APPLICATION NUMBER

5531

BOARD OF ZONING ADJUSTMENT

ANALYSIS APPLICATION 5531

SITE PLAN

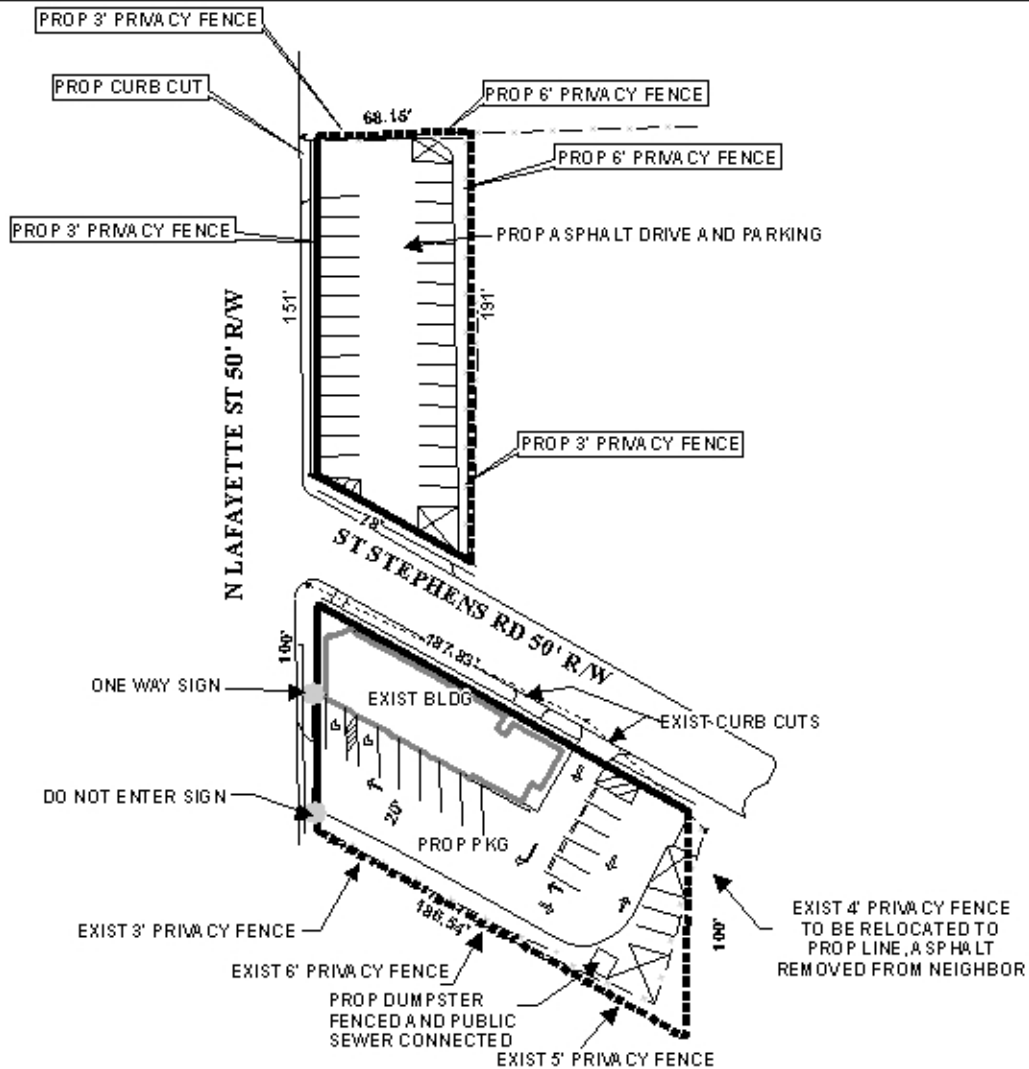
Traffic Engineering has reviewed the site plan and has determined that it is dysfunctional for the following reasons:

Lot 1

- 1) the driveways are not clearly shown;*
- 2) the narrow driveway should be signed "one-way" and/or "do not enter";*
- 3) the driveway radii appear to be less than 20';*
- 4) there is insufficient room for the northern-most parking stall to back out;*
- 5) the 20' wide aisle is too narrow (two-way traffic requires a 24' width).*

Lot 2

- 1) radii dimensions are not indicated;*
- 2) the asymmetrical stalls must be striped out since they will not accommodate cars;*
- 3) it is unclear if there is to be a drive on the South side, and if so, it should be indicated;*
- 4) the existing Southern most drive on the South side cannot function.*

As some of the items would require minor site plan revisions and clarifications, others are truly problematic. Two-way drive aisles must be 24' wide, for instance. Also, parts of the parking area and buffer fence on Lot 1 encroach onto the property to the East of the site. An on-site review of the site also revealed the dumpster against that fence, but there is no provision on the site plan for the dumpster and adequate vehicular access.

A revised site plan was submitted addressing most of the issues. Some curb cut issues could not be corrected due to the location of utility poles in the right-of-way. Further Traffic Engineering concerns beyond those cited in the holdover reasons were coordinated with that department and incorporated into the site plan. And the site plan now includes a properly located dumpster and enclosure, and elimination of the privacy fence and paving encroachments onto the neighboring property along St. Stephens Road.

- 1) modification of the recently-added parking areas to match the revised site plan of June 19, 2009;*
- 2) all directional arrows applied to paving to be Thermoplastic as approved by Traffic Engineering;*
- 3) installation of parking lot lighting in compliance with Section 64-6.A.3.c. of the Zoning Ordinance, specifically so arranged that the source of light does not shine directly into adjacent residential properties or into traffic;*
- 4) obtaining of any “after-the fact” permits normally required for improvements already made, and obtaining of any permits required for further improvements; and*
- 5) provision of landscaping and/or tree plantings in areas not paved, to be coordinated with Urban Forestry;*
